CITY OF ALBUQUERQUE

RE: **13424 Cedarbrook Ave NE**
Grading and Drainage Plan
Engineer's Stamp Date: 11/5/18
Drainage File: F23D013

DRAINAGE AND TRANSPORTATION INFORMATION SHEET (REV 6/2018)

**RE: 13424 Cedarbrook Ave NE
Drainage file F23D013**

HEC-RAS Plan: Plan 01 River: GLENWOOD HILLS Reach: CEDARBROOK CROSS Profile: PF 1

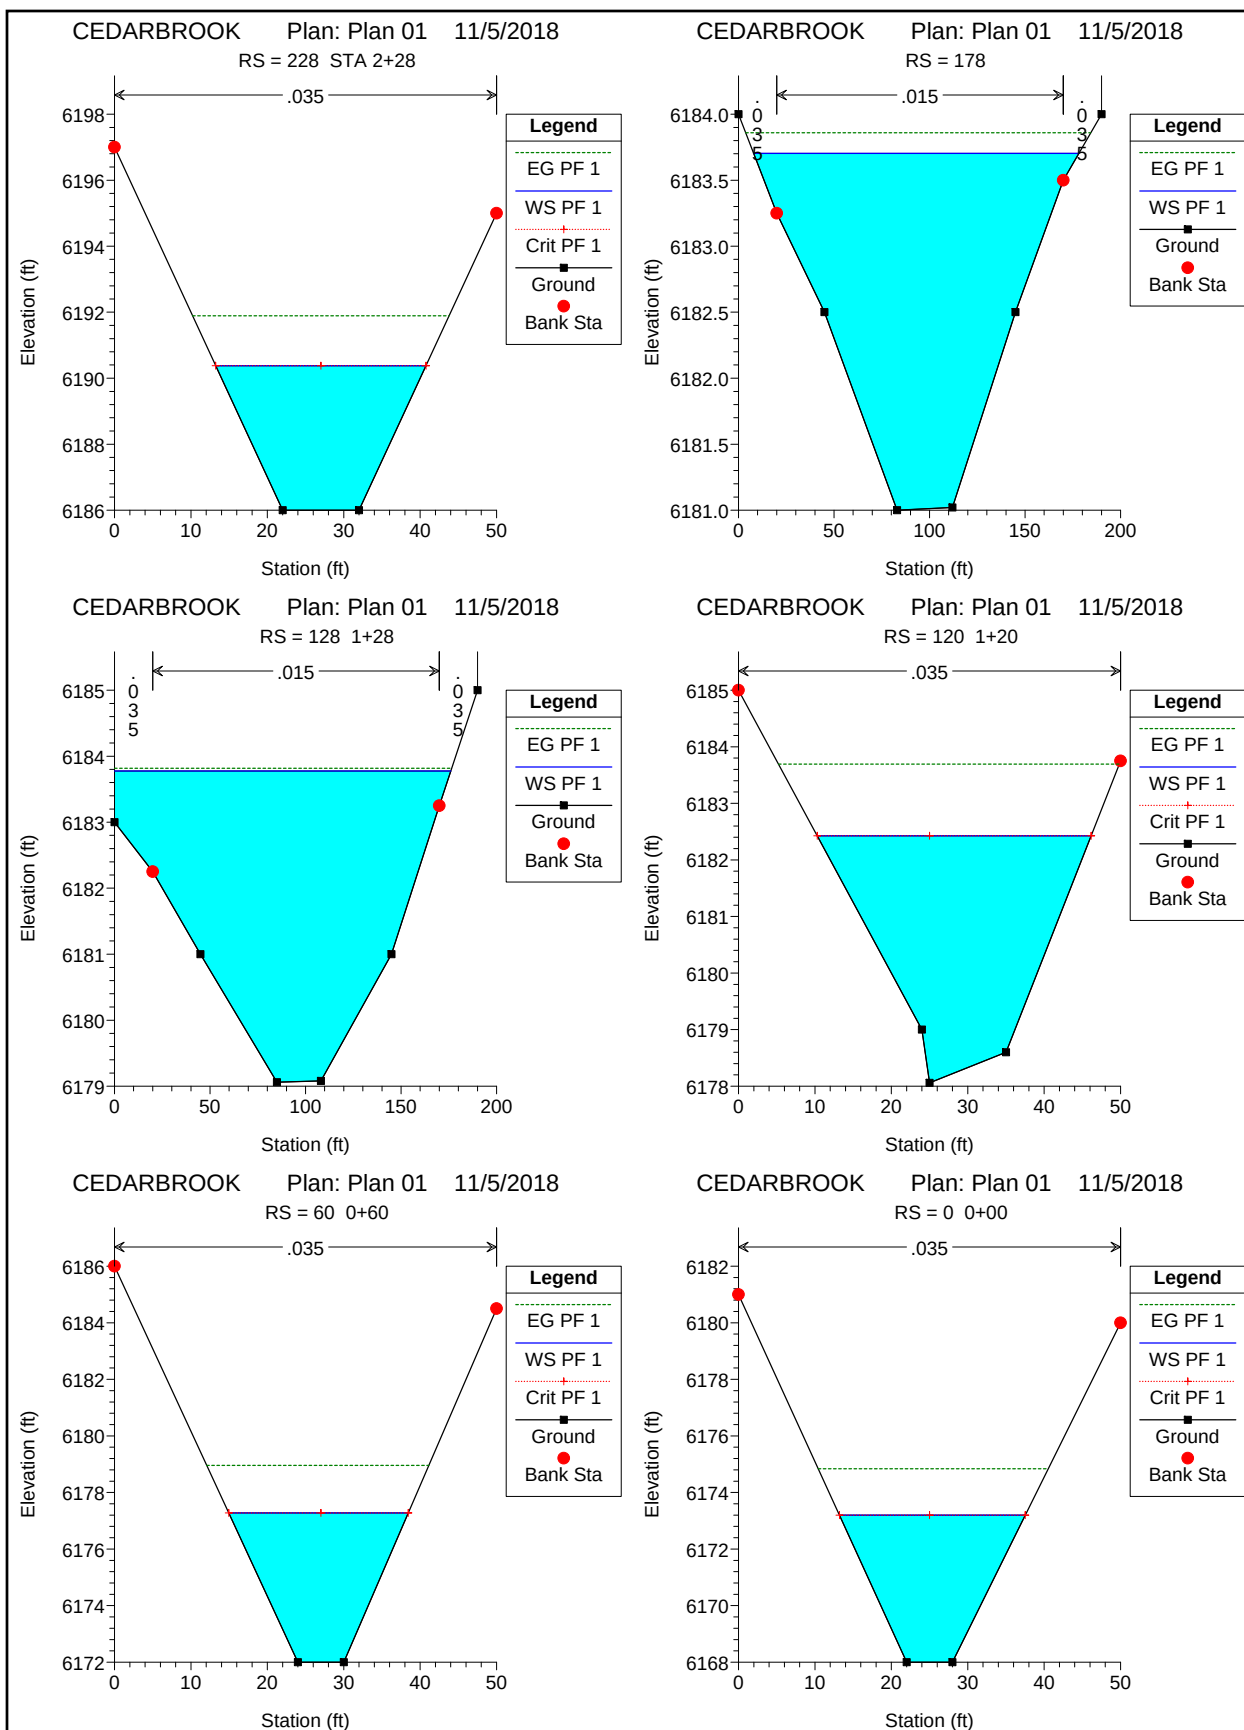
1. Please update the stamp date. **UPDATED**
2. The 40-acres or less method is not reasonable for this watershed; provide subbasins and an AHYMO model or HEC-HMS model to determine Q_{100} . **AYHMO ATTACHED**
3. Provide a profile of the arroyo, beginning at the upstream edge of Cedarbrook Place crossing. Include: bottom of arroyo, normal depth, critical depth, top of existing and proposed banks, the proposed building pad and freeboard. **PROVIDED HEC RAS /WITH CROSS-SECTIONS**
4. Provide freeboard per DPM Ch22.C.4. Freeboard will need to be measured from the water surface on the road crossing to the top of the pad. If flows are calculated as supercritical; then the critical depth will need to be used as the controlling water surface **FLOOD WALL PROVIDES**
5. Show the adjacent grades in N Glenwood Hills Arroyo; ensure that your grading ties-in at the ROW line. **ADDED**

The upland basin was analyzed utilizing AYHMO. The flow rate was utilized to model the arroyo and road crossing at Cedar brook utilizing HEC-RAS. The corresponding information was added to the updated grading plan. We feel we have provided a plan that conforms to the DPM

ENGINEER'S SEAL 11/5/18 DAVID SOULE P.E. #14522	13424 CEDARBROOK AVE.	DRAWN BY DEM
	GRADING AND DRAINAGE PLAN	DATE 9-23-2018
	 Rio Grande Engineering 1800 CENTRAL AVENUE SUITE 201 ALBUQUERQUE, NM 87108 (505) 872-0000	SHEET # 1 OF 1
		JOB # XXXXX

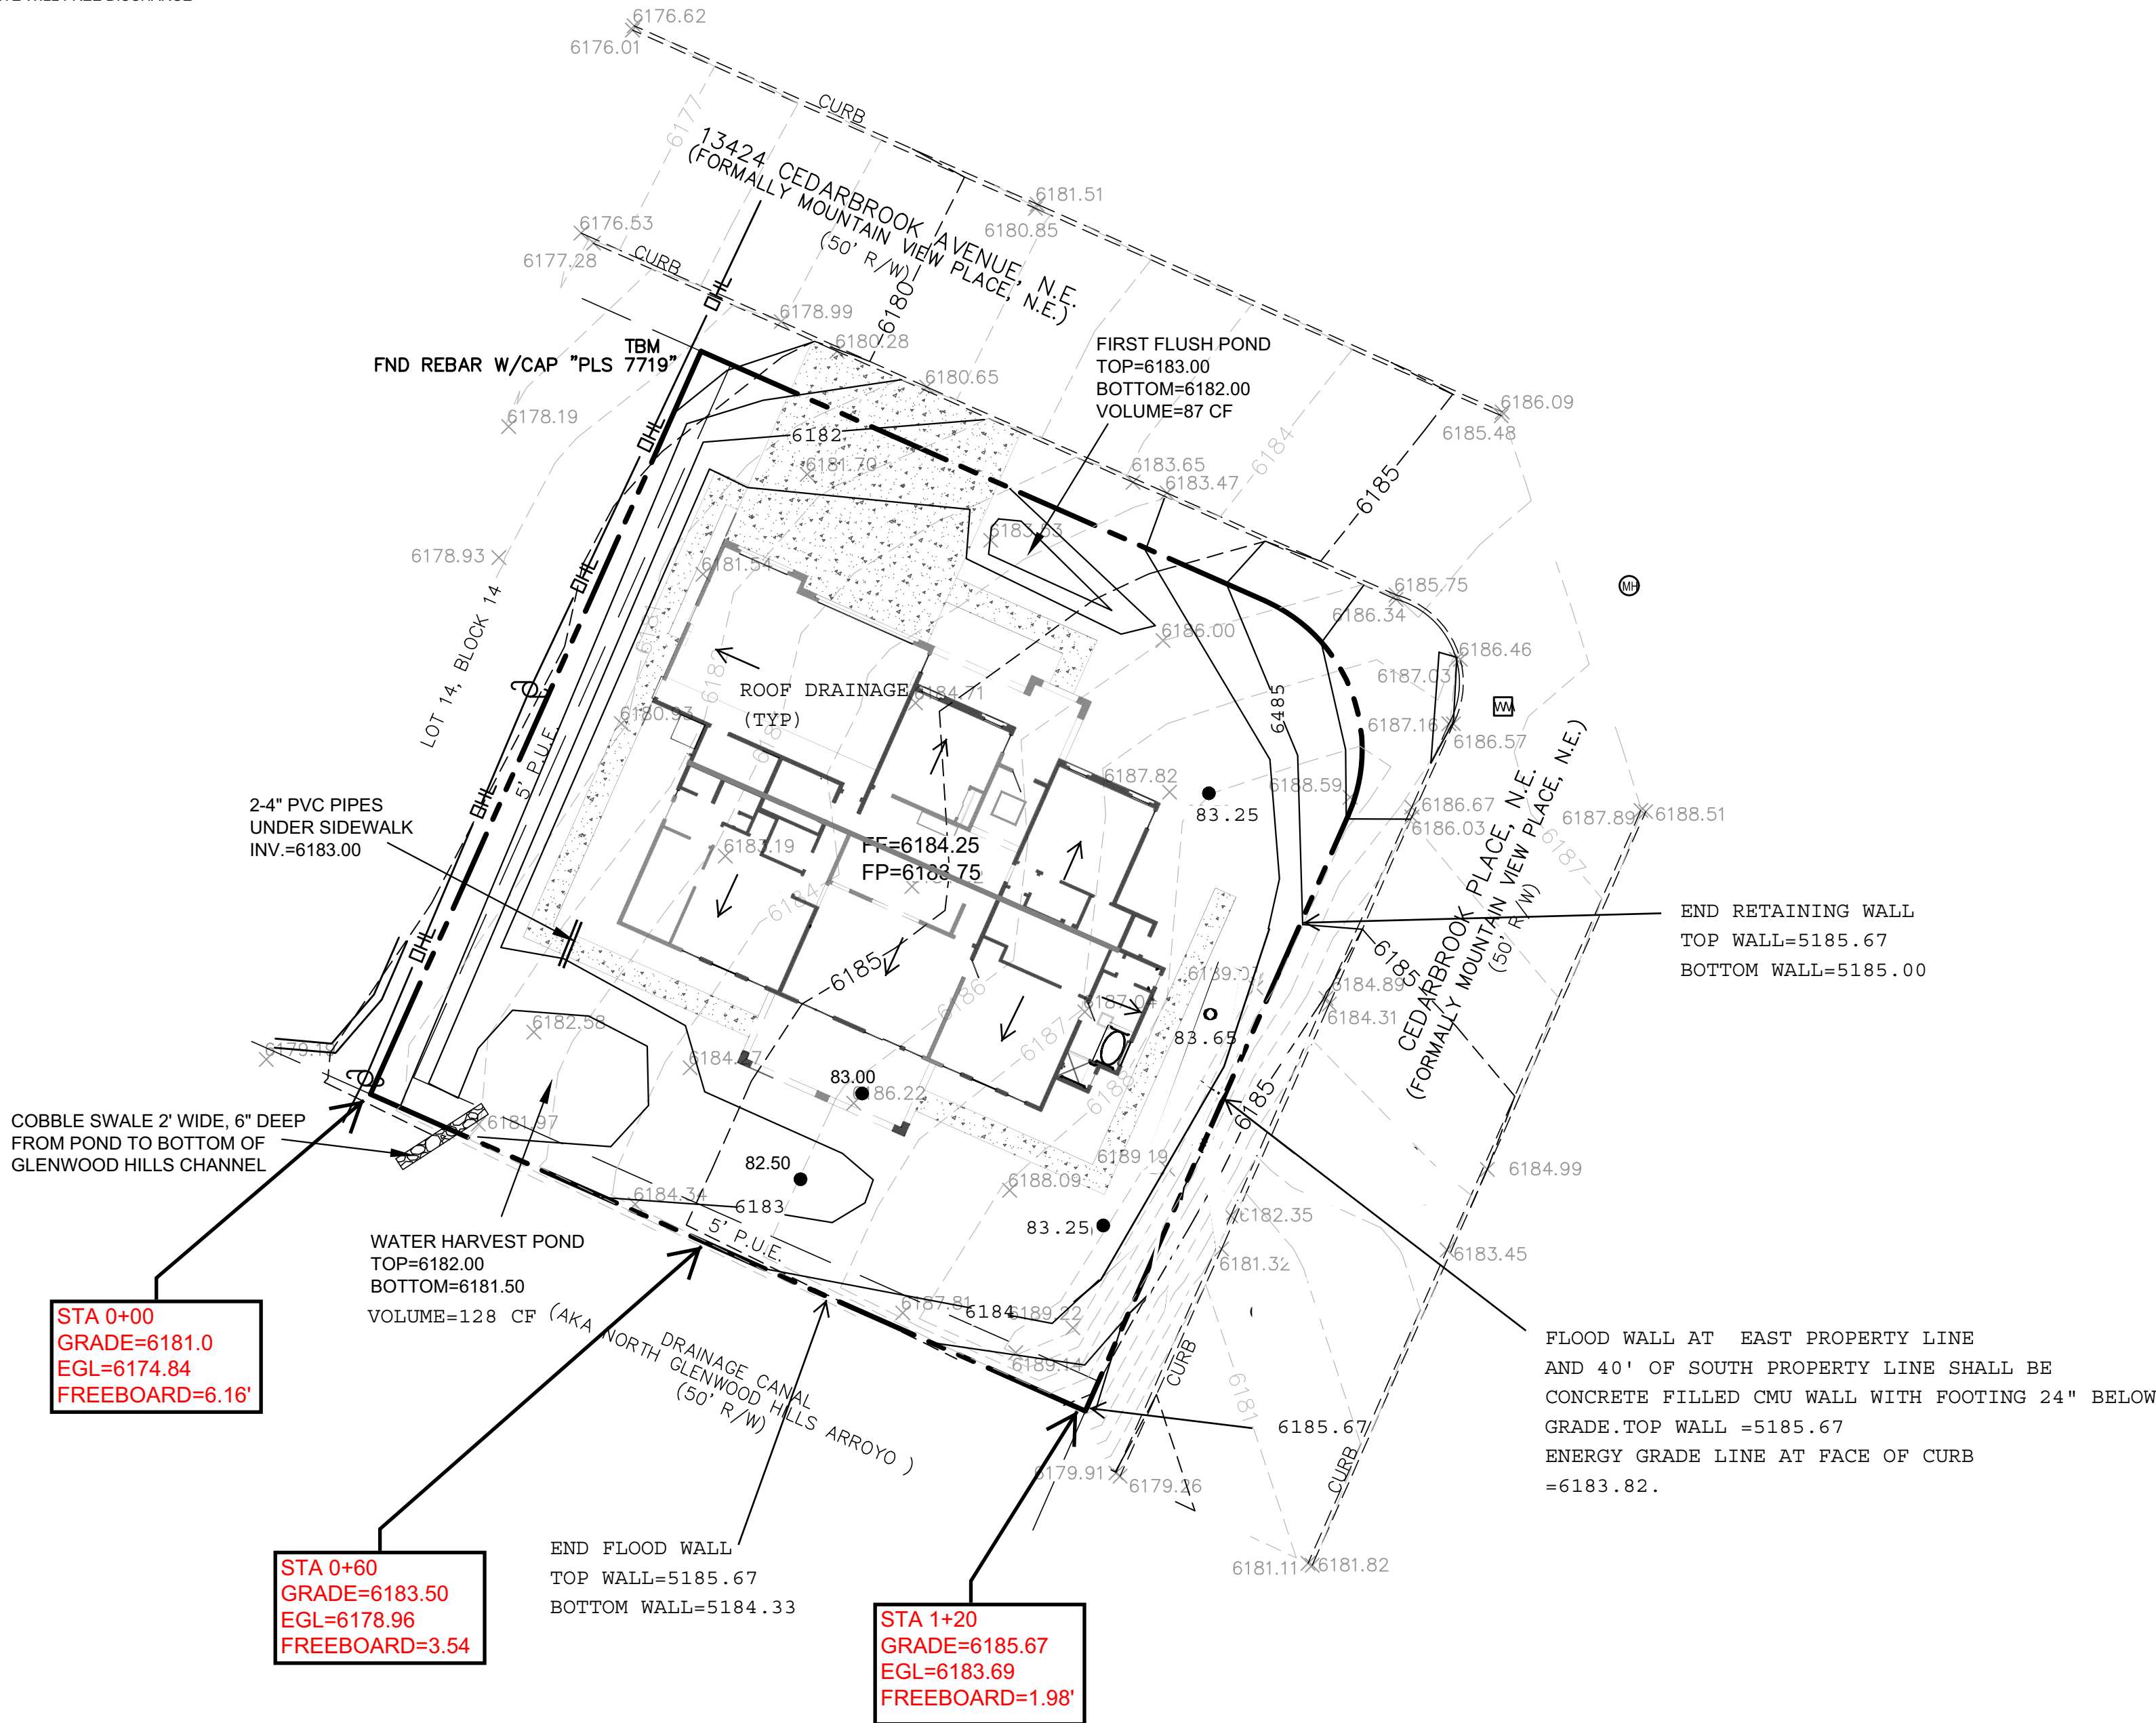
1. Show the freeboard wall in plan view and provide sections (east wall and south wall). Ensure the wall and footer do not encroach on either ROW. Any private encroachment into the public ROW will require a revocable permit.

Requirements, the grades at the property line provide almost 2' of free board above the Energy Grade Line and a solid CMU wall has been added for additional reinforcement
